RESPONSE TO APPLICATION TO PLACE TABLES & CHAIRS ON THE HIGHWAY AT THE LOCATION DETAILED BELOW

Location: **The Waiting Room, Cattle Market, CT13 9AE**

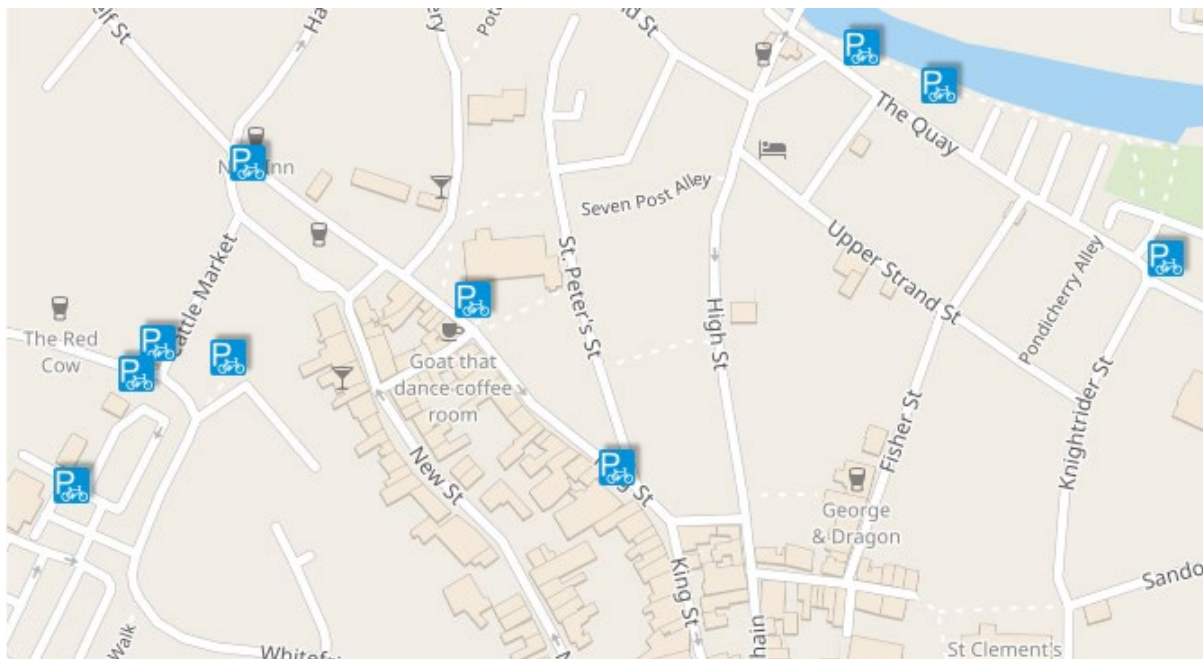
KCC, as the Highway Authority, would object to the application in its current form. Whilst there is sufficient width to accommodate the tables and chairs as indicated to the front of the property, and retain 1.5m unobstructed footway width for pedestrians, there is insufficient width to accommodate those shown to the side of The Waiting Room due to the presence of a number of cycle parking racks.

There is no shortage of cycle parking within the town, as shown on the map below, but given the move towards greener, more sustainable modes of transport, KCC could not agree to the removal of the cycle racks in question. However, given that fact that the existing racks are seldom fully utilised, and to ensure that there was no overall detriment to the cycle parking provision in the town, we would not object to their relocation if all costs were met by the applicant.
